#### APPEAL SUMMARY

Appeal ID: 16563	Project Address: 5209 SE 18th Ave
Hearing Date: 2/28/18	Appellant Name: Gunnar Langhus
Case No.: P-002	Appellant Phone: 503-245-7100
Appeal Type: Plumbing	<b>Plans Examiner/Inspector:</b> Ed Matthews, Joe Blanco, McKenzie James
Project Type: commercial	Stories: 6 Occupancy: S-1, S-2, R-2 Construction Type: I-A, III-B
Building/Business Name:	Fire Sprinklers: Yes - (location not given
Appeal Involves: other: drywell near foundation wall	LUR or Permit Application No.: 16-197547-CO
Plan Submitted Option: pdf [File 1] [File 2]	Proposed use: multi-family housing

Re: SE 18th Apartments Dry Well Adjacent to Foundation

FIGURE 1

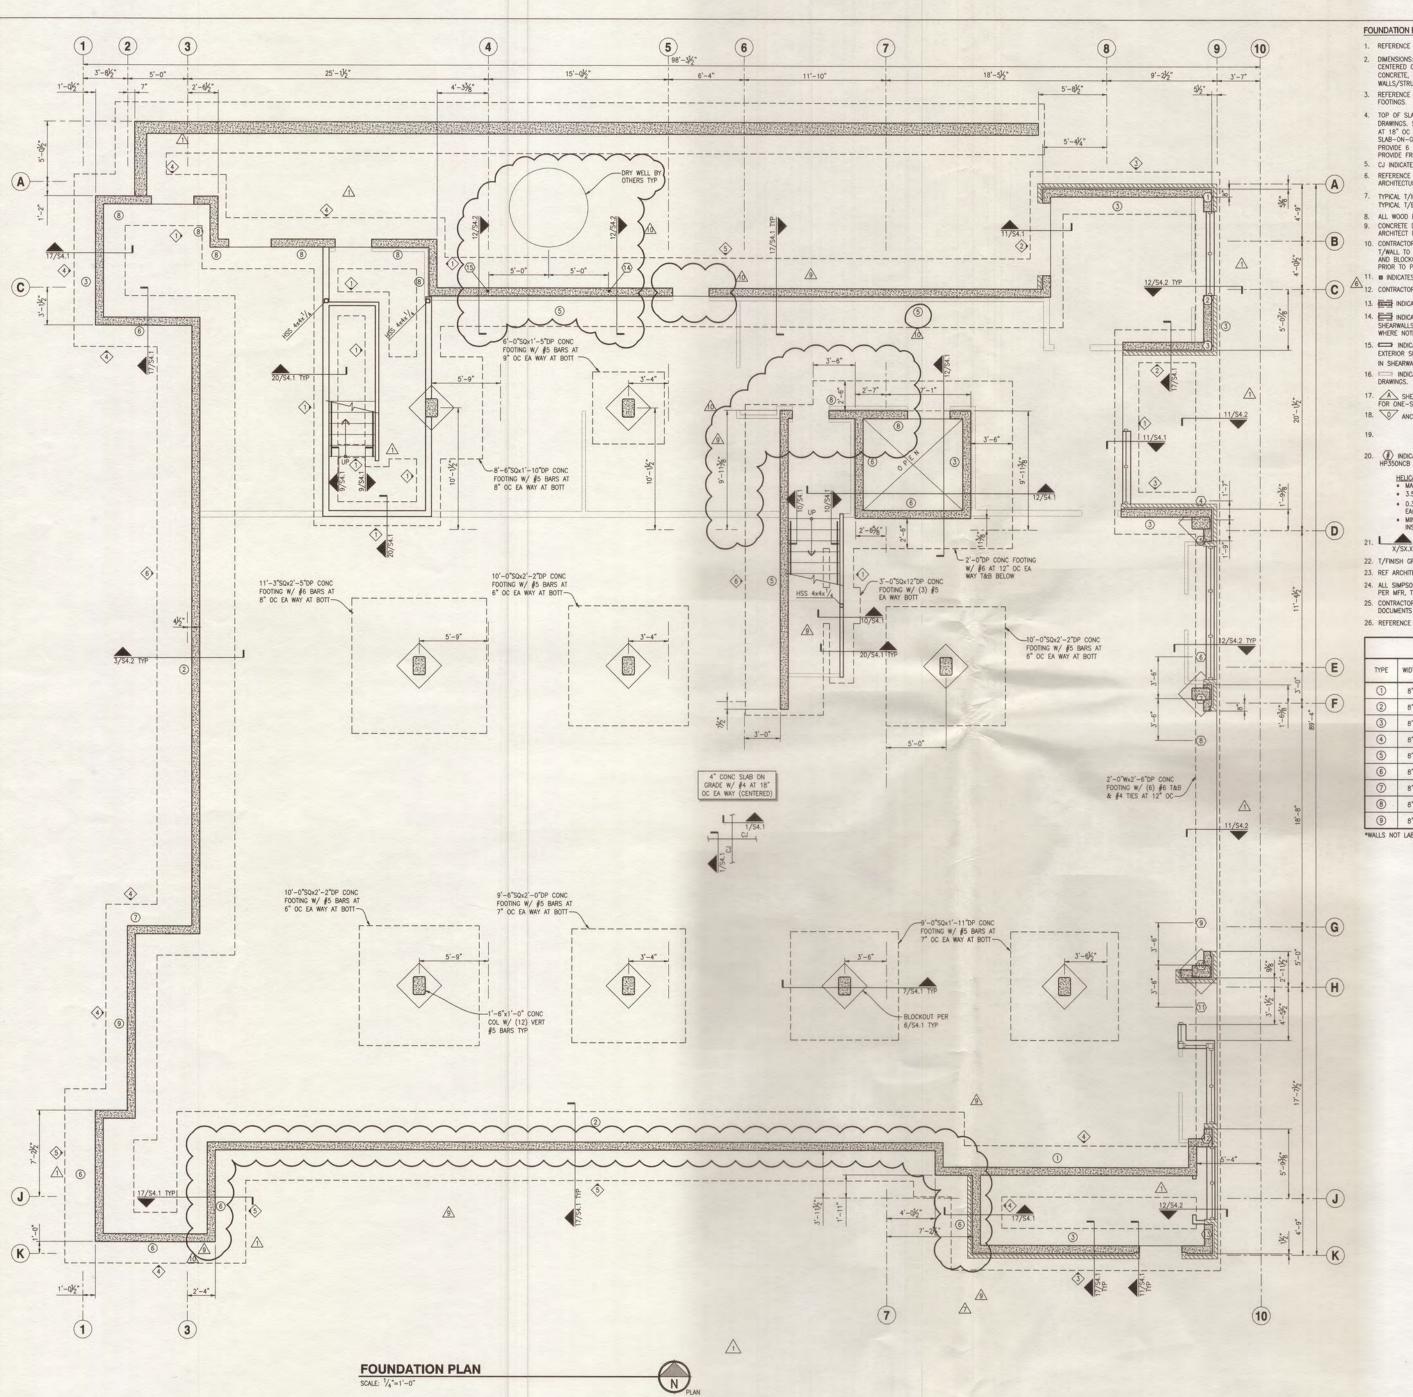
As requested, Hardman Geotechnical Services Inc. (HGSI) performed supplemental soil infiltration testing for the property located at 2915 SE Division Street in Portland, Oregon (Figure 1). HGSI previously completed a geotechnical report for the site, referenced above. The purpose of this supplemental work was to further evaluate infiltration rates for subsurface disposal of storm water. We understand that design of the stormwater infiltration system is to be completed by others. Results of the infiltration testing are summarized below.

Soil infiltration testing was performed using the open hole, falling head method in test pit TP-1. Soils in the test pit were pre-saturated prior to testing. Following the soil saturation, the infiltration test was conducted. The water level was measured to the nearest 0.1 inch from a fixed point. The change in water level was recorded at intervals for a total period of at least 1 hour. Table 1 presents the results of the falling head infiltration tests.

Based on results of the soil infiltration testing, soils on site exhibit moderate infiltration rate (4 inches/hour at depth of 14 feet bgs). We recommend shallow systems in the range of 2 to 5 feet bgs be designed using an infiltration rate of 1 inches/hour as recommended in the above-referenced geotechnical report. Based on results of this supplemental testing an ultimate infiltration rate of 4 inches/hour may be used to design deeper facilities such as dry wells, installed deeper than 10 feet bgs. We do not recommend infiltration facilities deeper than about 15 feet bgs to provide adequate separation between the bottom of the facility and seasonal high groundwater level (23 feet).

S2.1 AS SHOWN

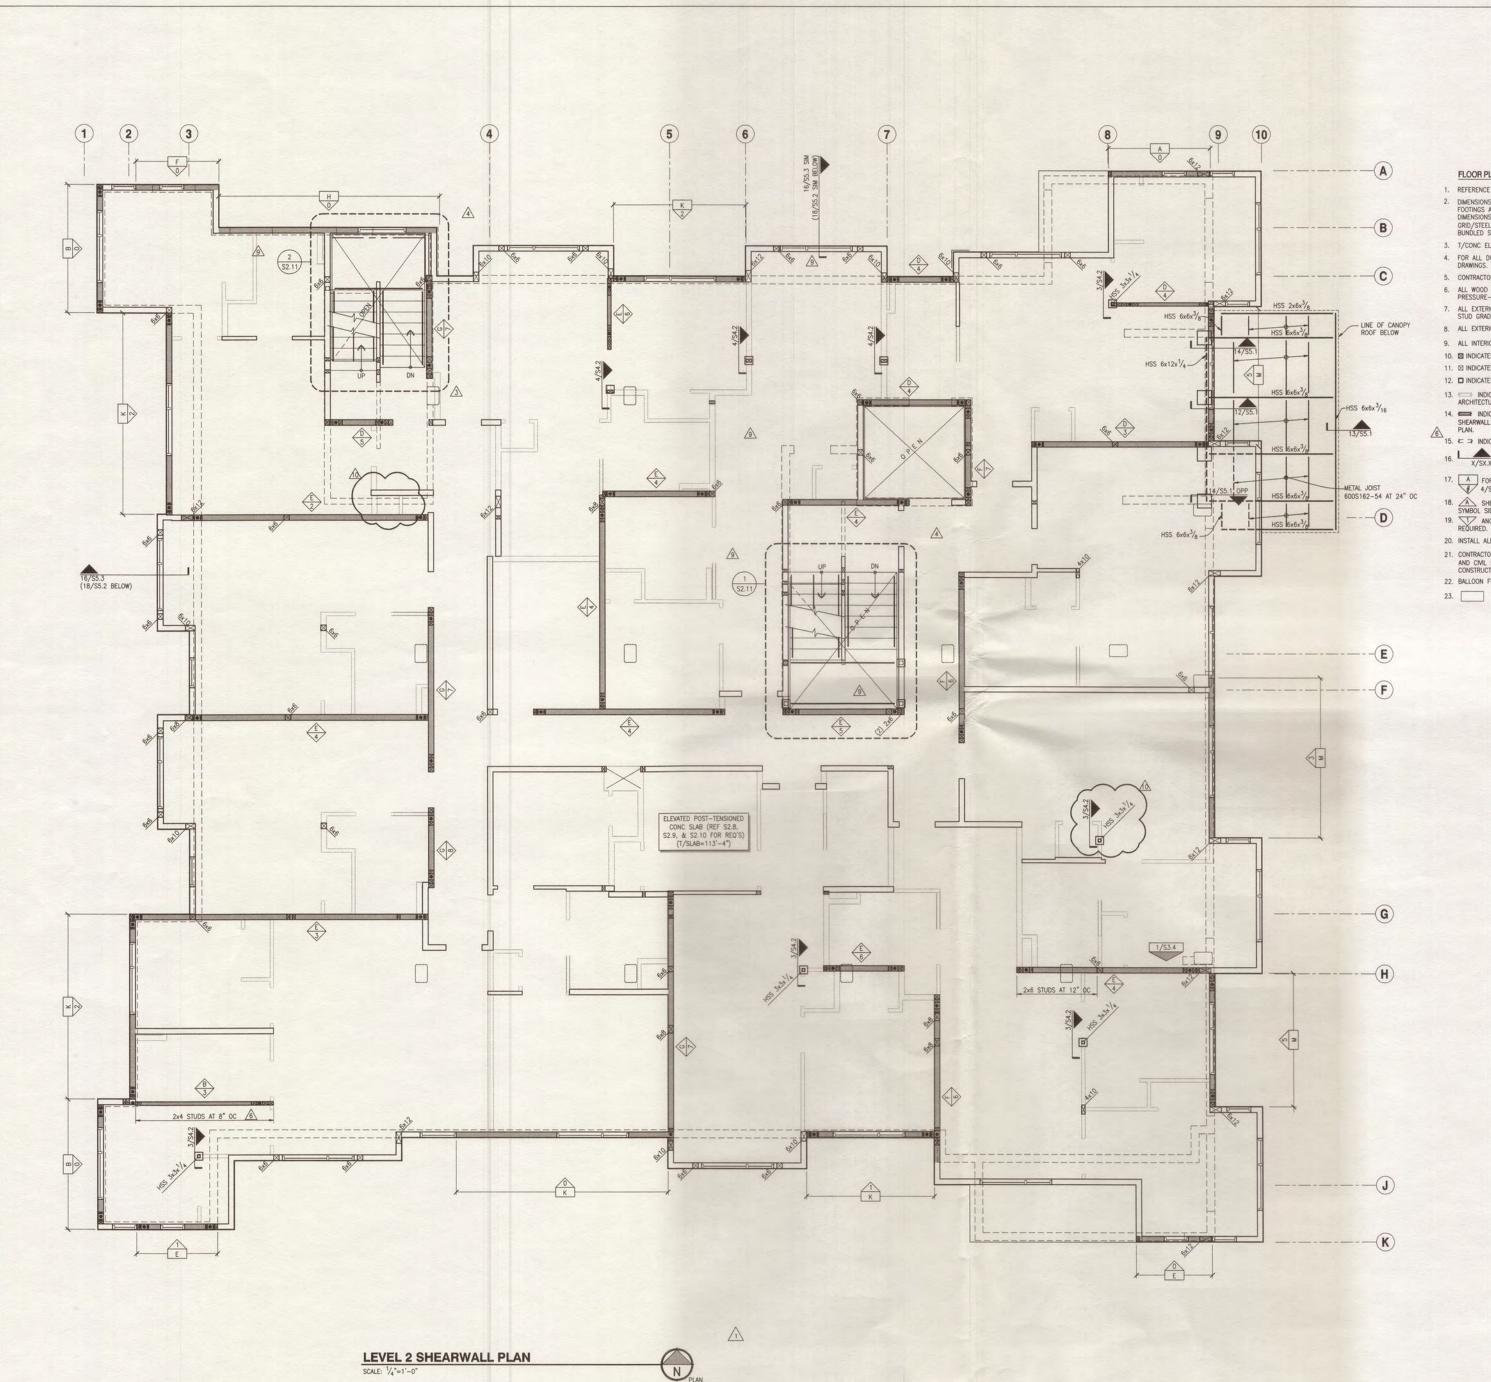
#### **Proposed Design** Proposed design locates the drywell within 6.7' of the building foundation wall.

Reason for alternative On the north side of the proposed building there is approximately 14' between the property line and the proposed building face. Due to this dimension, the drywell cannot be placed 5' from the property line while also being 10' from the building. Due to proposed piping design and layout, as well as to limit the effects on the adjacent property as much as possible, the dry well was located within the proposed sidewalk at approximately the mid point between the building and the property line. This located the center of the drywell at 6.7' from the building and 7.3' from the property line.

We have reviewed the information that you provided us regarding the potential impact of the drywell location to the new structure's footings on the north side of the property. There will be no impact on the new structure's foundation as we have designed the portion of the footing adjacent to the drywell to be supported by helical piles to a depth well below the base of the drywell as shown on sheet S2.1.

Drywell closer than 10' to building: Granted provided engineering details are followed.

Note: soils and structural will need to be reviewed again by BDS.
